Access Compliance Report

Public Rights-of-Way

(Curb Ramps)

Intersection ID: 13639	Main Street: BRIAR_CREEK_RD	Cross Street: CENTRAL_AV	Location: NW
ADA ID: 73849626514E	Ramp Type: Perp	Initial Pass/Fail: Fail	Overall Compliance: No
Severity Score: 21.25			
Codes/Mitigation Info/Possible Solution		Field Measurements/Component Compliance

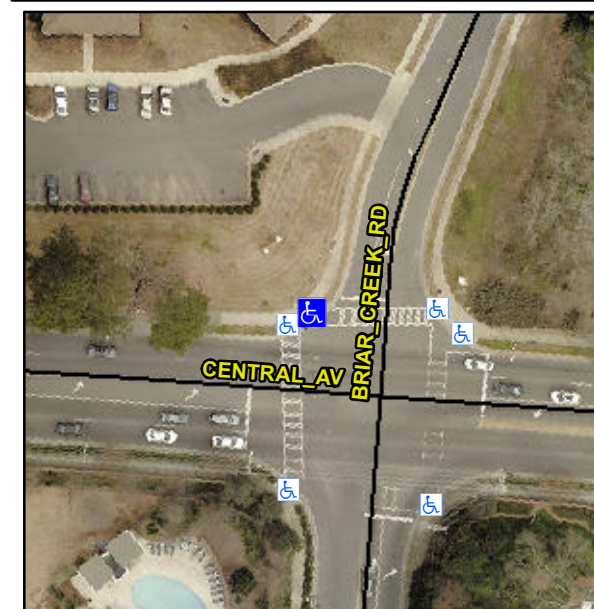
Not Found, R304.5.1, R304.2.2

Compliance	Description	Data	Compliance	Description	Data
N/A	Ramp Length (in)	49.0	No	Ramp Slope (%)	9.0
No	Ramp Width (in)	46.0	Yes	Ramp XSlope (%)	0.9
N/A	Flare Type LT	N/A	N/A	Flare Type RT	N/A
N/A	Flare Slope LT (%)	N/A	N/A	Flare Slope RT (%)	N/A
N/A	Flare Traversable LT?	N/A	N/A	Flare Traversable RT?	N/A
N/A	Landing Length (in)	N/A	N/A	DWS Provided?	N/A
N/A	Landing Width (in)	N/A	N/A	DWS Contrast?	N/A
N/A	Landing Slope (%)	N/A	N/A	DWS Length (in)	N/A
N/A	Landing X Slope (%)	N/A	N/A	DWS Full Width?	N/A
N/A	Landing Curb? (Y/N)	N/A	N/A	DWS Offset (in)	N/A
N/A	Shared Landing?	N/A			
N/A	Gutter Ponding?	N/A	N/A	Gutter Slope (%)	N/A
N/A	Gutter Lip Ht (in)	N/A	N/A	Gutter X Slope (%)	N/A
N/A	Painted X Walk1?	Yes	N/A	Painted X Walk2?	N/A
	X Walk 1 Direction	To E		X Walk 2 Direction	N/A
N/A	X Walk 1 Width (in)	93.0	N/A	X Walk 2 Width (in)	N/A
	X Walk 1 Slope (%)	5.2		X Walk 2 Slope (%)	N/A
	X Walk 1 X Slope (%)	0.9		X Walk 2 X Slope (%)	N/A

Remove & Replace Entire Ramp.
